# AGENDA CITY OF CEDAR FALLS, IOWA PLANNING AND ZONING COMMISSION MEETING WEDNESDAY, MAY 11, 2022 5:30 PM AT CEDAR FALLS COMMUNITY CENTER, 528 MAIN STREET

**SUBJECT:** FP22-001 Wild Horse Fifth Addition Final Plat

REQUEST: Request to approve the Wild Horse Fifth Final Plat. Case #FP22-001

### FINAL PLAT WILD HORSE RIDGE FIFTH ADDITION

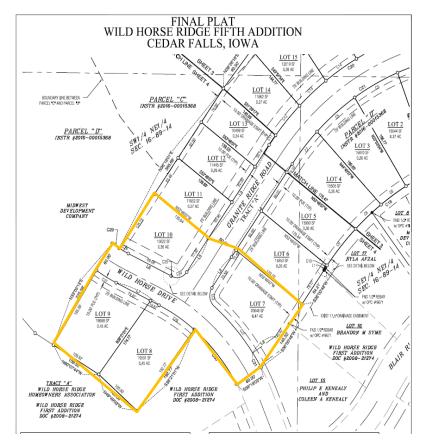
As originally proposed, the petitioner planned to have the Fifth Addition as 15 lots that did not

include the connection between Wild Horse Drive and Granite Ridge Road (highlighted in yellow above). Engineering Division and the Public Safety Department encouraged the connection between Wild Horse Drive and Granite Ridge Road to increase the connectivity of the existing subdivision and eliminate a dead end on Granite Ridge Road. The preliminary plat was approved prior to the new code requirements of addressing critical infrastructure through a phasing plan. Planning Staff has no objections to the additional 4 lots (highlighted in yellow on the right) and adding the intersection of Wild Horse Drive and Granite Ridge Road. The petitioner will connect to the existing stormwater detention. The City's maintenance and repair agreement with the owner/developer will address maintenance responsibilities for the stormwater

The City Code states that the final plat must be in substantial conformance with the preliminary plat. The proposed change does not change the density, lot size, or configuration of the lots. The proposed change increases safety and connection within the subdivision. Therefore, staff finds that the proposed final plat is conforming with the preliminary plat and associated conditions. The petitioner has met that criterion and the associated conditions.
